3. UPGRADE KIT FOR CHANGING TO NEW BEARING AND ADJUSTMENT BRACKET IN THE SHUTTLE FOR HM604 LOOMS

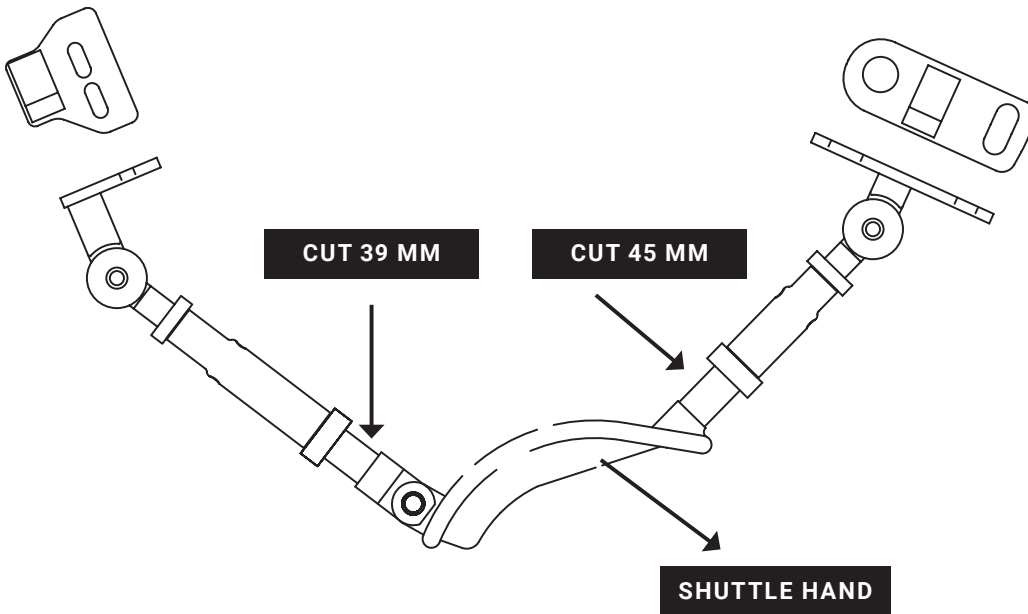
OBS
SHUTTLE HAND
SCREWS MUST BE
CUT TO FIT THE
NEW ADJUSTMENT
BRACKET FOR
SHUTTLE HANDS
